From: Allison Schieber
Sent: Thursday, May 5, 2022 2:59 PM
To: Allison Schieber
Subject: FW: [External]:Re: [External]:Re: [External]:Re: [External]:Re: [External]:Re: Helen 2536 Pad COA

Our Helen 2536 Pad lists UPRR-Ancell 11-1 (05-123-08561), as an Option 3. If we don't complete within 1500' of the well, can we do option 4? The very end of the Helen 2536-05H (05-123-46821) is the only lateral that falls within 1500' of the well.

Snip from GIS with a 1500' buffer on the Ancell for reference.

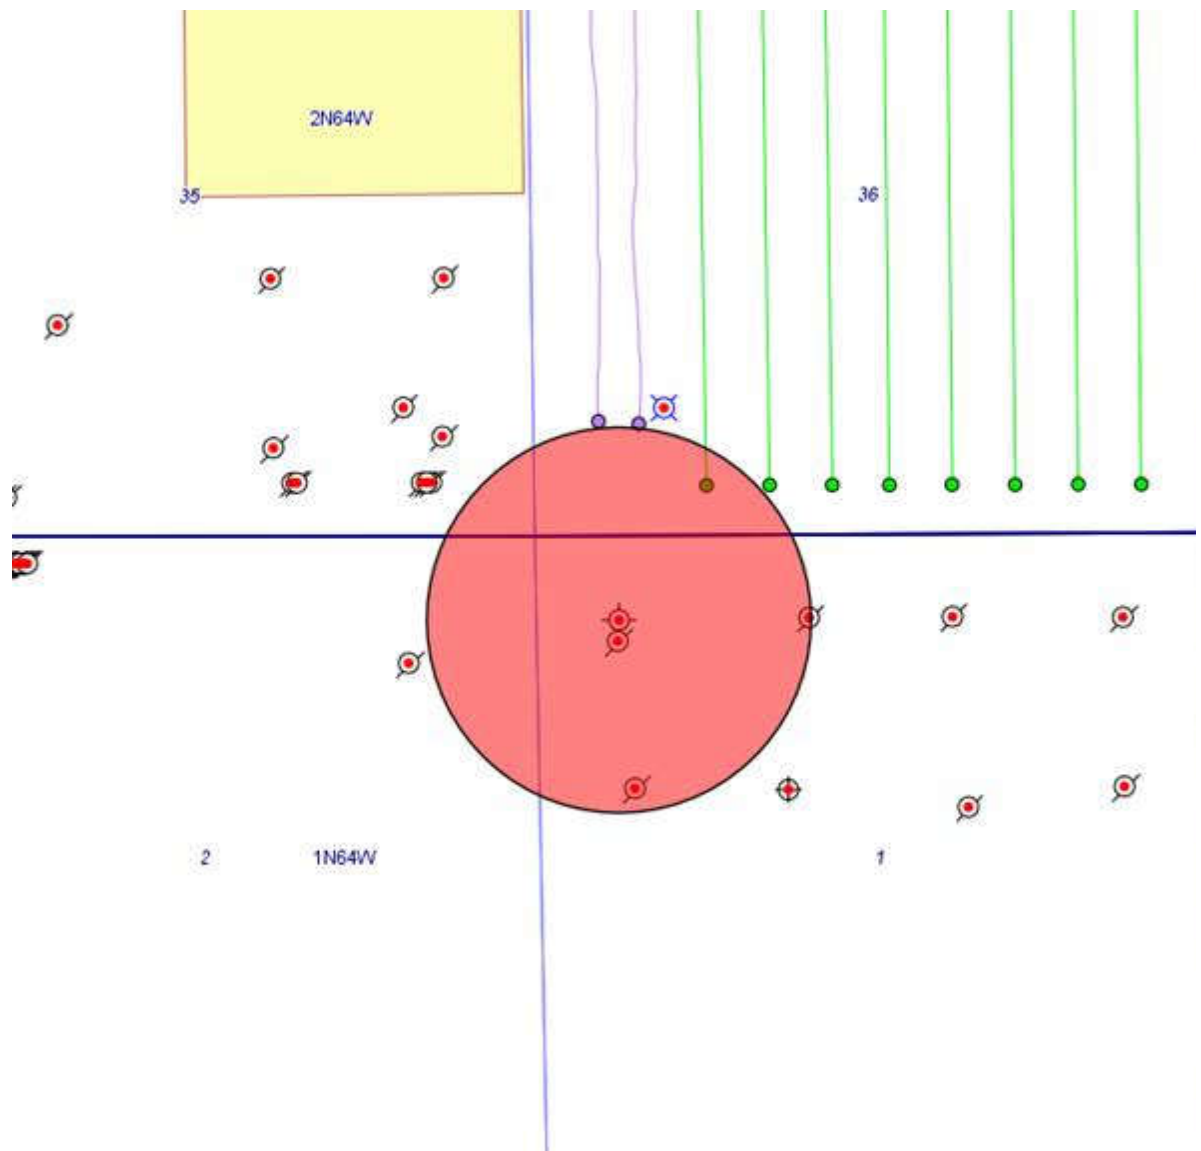
All good!
If the center to center can be measured from 16790' that should be enough.
Just to check - Verdad is ok forgoing that much productive interval?

That would be consistent with our rules.

Could you please submit this request on a form4 sundry for Helen 2536-05H (123-46821) including estimated MD that would be >1500' away?
